Subject: REAR CONSOLE LID DOES NOT LATCH CLOSE (BROKEN LATCH)	Bulletin No: 09-047/16
	Last Issued: 08/11/2016

This bulletin supersedes the previously issued bulletin(s) listed below. The changes are noted below in Red beside the change bars.

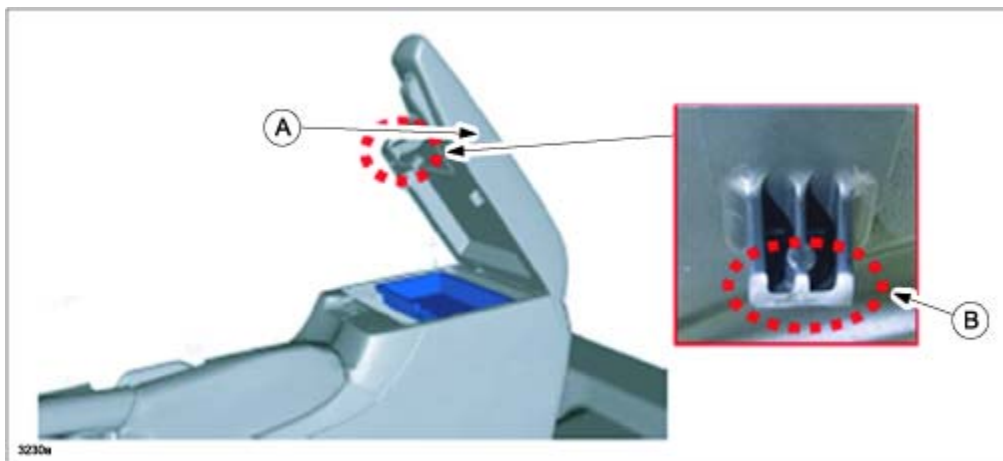
Some vehicles may exhibit the rear console lid (A) that does not latch close due to a broken latch (B). The latch may be broken by excessive external force applied to the lid. To eliminate the concern, the shape of the rear console lid latch has been changed to increase the strength.

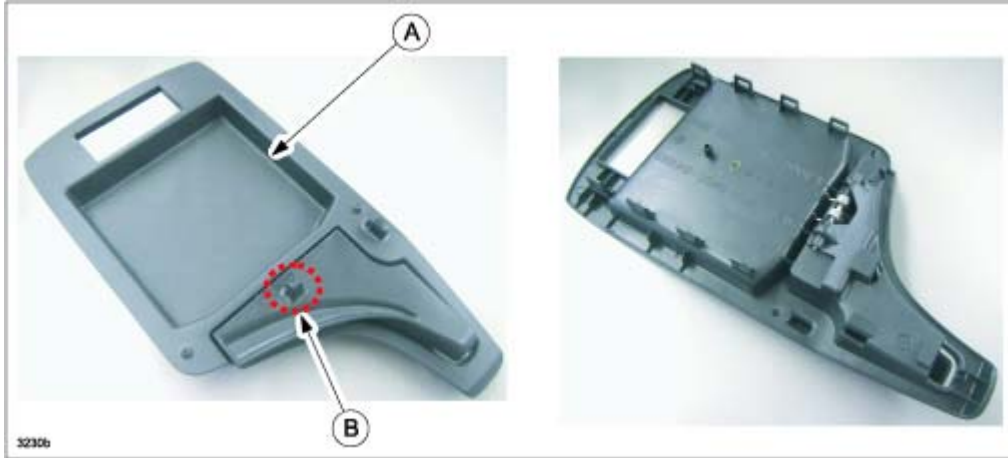
1. Verify customer concern.
2. Replace the console upper lid (A) with a modified latch (B) according to the instructions on MS3 online (CONSOLE LID REMOVAL/INSTALLATION).

NOTE: The console upper lid has been established as a new service part.
